**STAFF RECOMMENDATION**

**903 Gilmore Avenue**

**June 17, 2020**

**Application:** Converting Outbuilding to a DADU

**A:** Photographs

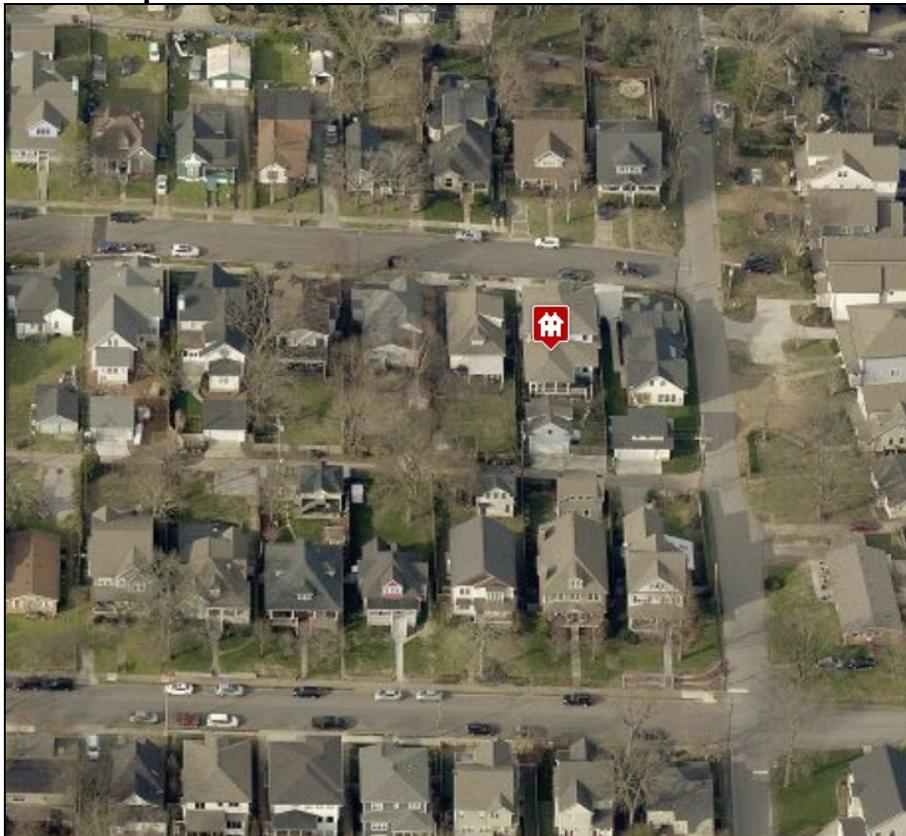
**Background:** The house and outbuilding at 903 Gilmore Avenue were constructed in 2016, prior to the establishment of the Waverly-Belmont NCZO. The owner is proposing to convert the outbuilding to a DADU.

COVER  
SITE PLAN

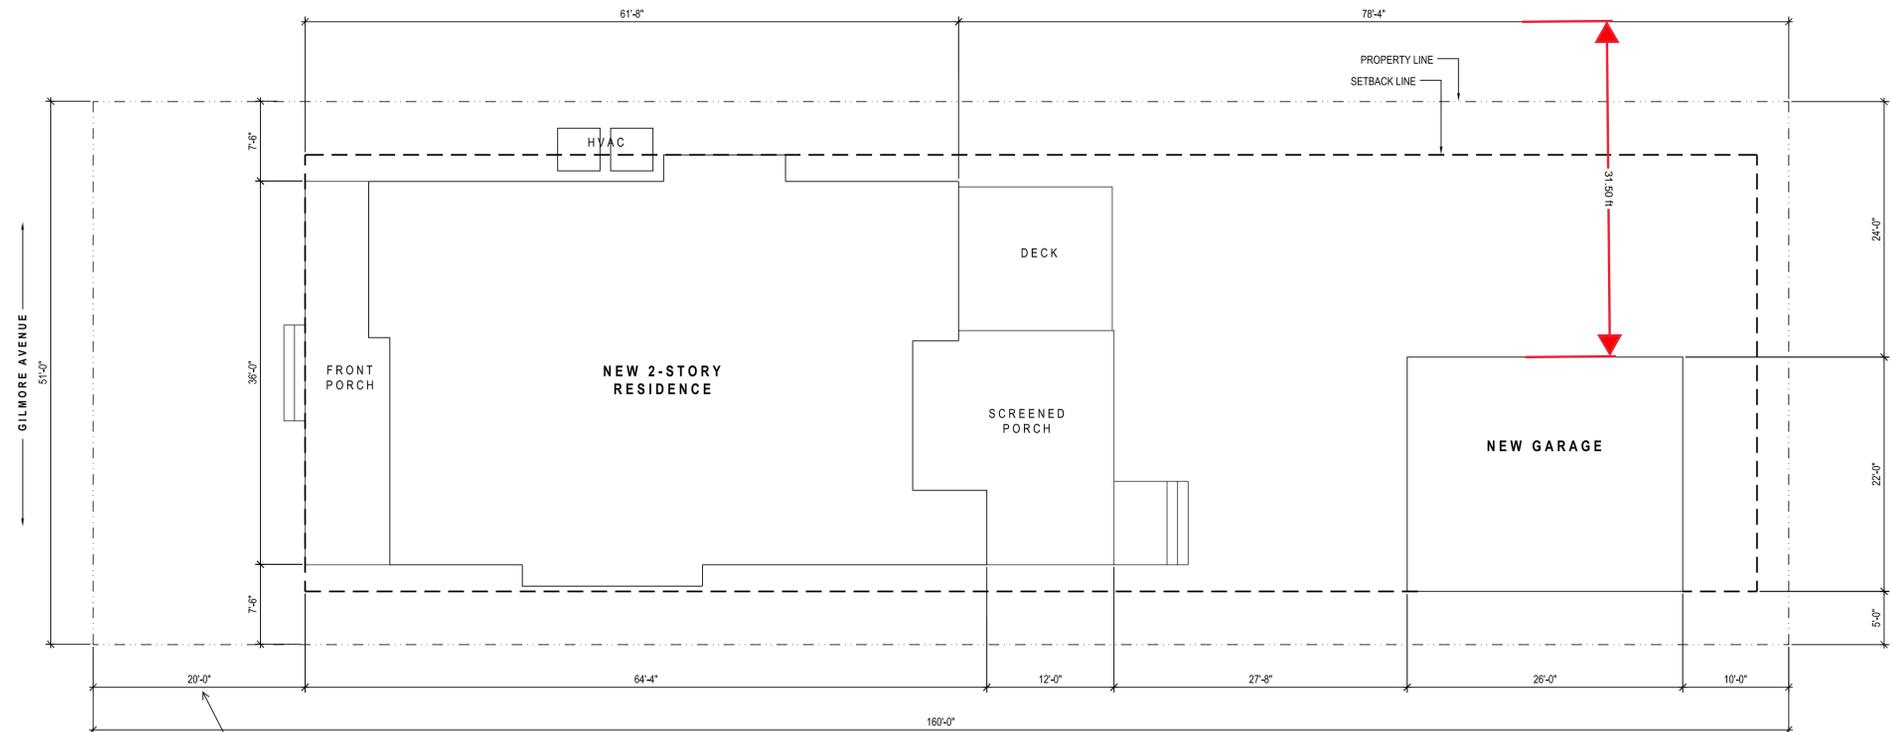
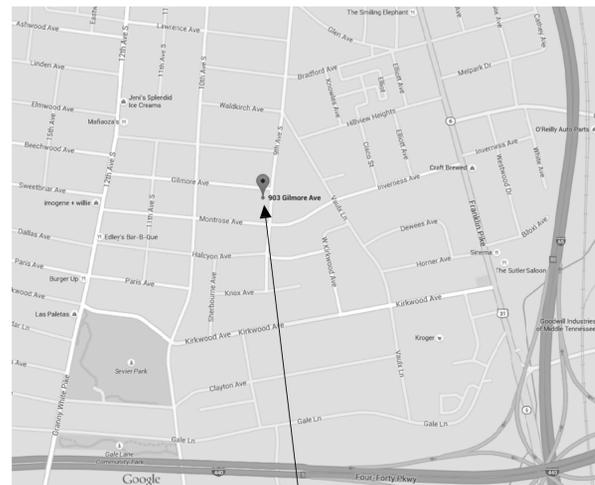
The lot is less than 10,000 square feet, at about eight thousand, one hundred-sixty square feet (8,160sqft). The existing building is well under the allowed maximum and therefore meets the requirements for square footage.

The ridge height is about twenty-two feet, six inches (22'6") tall, and the eaves are about fourteen feet (14') tall. These heights meet the requirements for an outbuilding with a two-story primary structure.

Outbuilding description:	Proposed	Minimum Rear/Alley Setback	Minimum Side Setback for interior lot lines	Distance Between Principal Building and Outbuilding
Footprint less than 700 sq. ft., Garage doors face alley		3’	3’	20’
Proposed	572sqft	10’	5’/31’5”	27’5”
